From: kent lersch <kentlersch@kirellahomes.com>
Sent: Tuesday, November 24, 2020 12:22 PM
To: Judith Espinoza
Cc: Elizabeth Nijkamp; Brian and Julia; Jeff Rice
Subject: Re: 18755 Rockbrook Zoning Review Comments (SFD201631)

Regarding Plat Note #17, it appears the submitted plot/site plan depicts the foundation of the proposed residential structure. The dimensional setback measurements 15'-10" and 13'-10" from the "no build" area to the structure depicted on the disapproved plot/site plan were based off the scale provided on the plot/site plan. Depict and denote the dimensional setback measurement from the closest point of the structure to the "no-build" area which shows the foundation outside the 20' setback to scale on resubmitted engineered stamped plot/site plan. Enclosed for your reference is the current Land Development Code for Section 5.4.3.(E) Projections into Setbacks. This should address your concerns regarding roof overhangs.

General	Legal Description	Related Documents
1: Subdivision		
Subdivision: YARBROUGH SUBDIVISION		
Phase: 014293

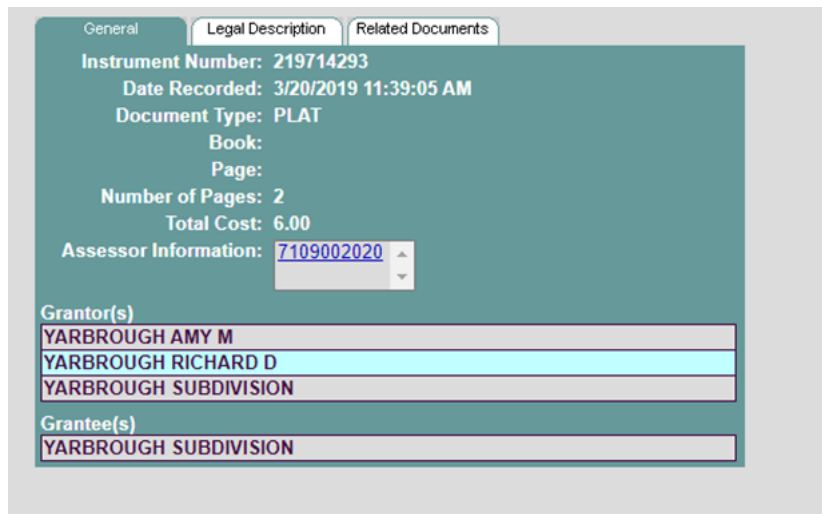
Please see the email from the property owners at 18755 Rockbrook Rd. Can you please confirm that we are all using the most recent, recorded plat, for this property?

I was reviewing the information and wondered if the county is referencing an old plat. From what I have found, through searching, the previous owners recorded a new plat on 03/20/2019 (screenshot below) and it is recorded under phase: 014293. The plat referenced in the email from the county is referenced as 14293 (not sure if the 0 makes any difference). The notes they referenced do not match the new plat. I have attached the Yarbrough subdivision plat that I believe was recorded on 3/20/2019 which makes no reference to the bedrock or shallow foundation. I am not sure if this is helpful at all but if they are referencing an old plat then their objections to a basement are unfounded.

The plats are identical and we are both using the most recent recorded plat on file for the property. The recording number is identical for the plat noted in the email trail below and the plat that our department has on file (Reception Number 219714293). Plat note 20 reads the same for both as follows:
